Access Compliance Report

Public Rights-of-Way

(Curb Ramps)

Intersection ID: 17670	Main Street: RIDGEWOOD_AV	Cross Street: SELWYN_AV	Location: NW
ADA ID: B409D2B98E5D	Ramp Type: Directional1	Initial Pass/Fail: Fail	Overall Compliance: No
		Severity Score: 1.25

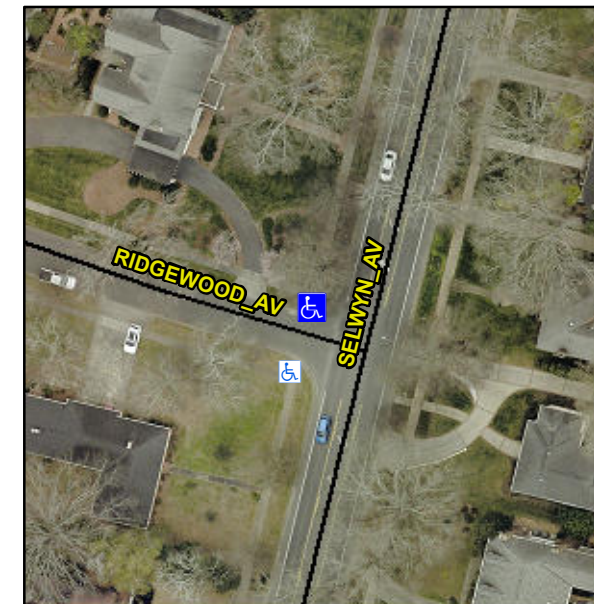
R304.5.3

Compliance	Description	Data	Compliance	Description	Data
N/A	Ramp Length (in)	63.0	N/A	Grade Break?	N/A
Yes	Ramp Width (in)	59.0	N/A	Grade Break Slope (%)	0.0
Yes	Ramp Slope (%)	6.7	N/A	Grade Break XSlope (%)	0.0
No	Ramp XSlope (%)	3.3			
N/A	Flare Type LT	N/A	N/A	Flare Type RT	N/A
N/A	Flare Slope LT (%)	N/A	N/A	Flare Slope RT (%)	0.0
N/A	Flare Traversable LT?	N/A	N/A	Flare Traversable RT?	N/A
N/A	Landing Length (in)	0.0	N/A	DWS Provided?	N/A
N/A	Landing Width (in)	0.0	N/A	DWS Contrast?	N/A
N/A	Landing Slope (%)	0.0	N/A	DWS Length (in)	N/A
N/A	Landing X Slope (%)	0.0	N/A	DWS Full Width?	N/A
N/A	Landing Curb? (Y/N)	N/A	N/A	DWS Offset LT (in)	N/A
N/A	Shared Landing?	N/A	N/A	DWS Offset RT (in)	N/A
N/A	Gutter Ponding?	0.0	N/A	Gutter Slope (%)	N/A
N/A	Gutter Lip Ht (in)	0.0	N/A	Gutter X Slope (%)	N/A
N/A	Painted X Walk1?	No		Road Slope (%)	5.3
	X Walk 1 Direction	To SW		Road X Slope (%)	0.3
	X Walk 1 Width (in)	N/A		Clear Space?	N/A

Remove & Replace Entire Ramp.
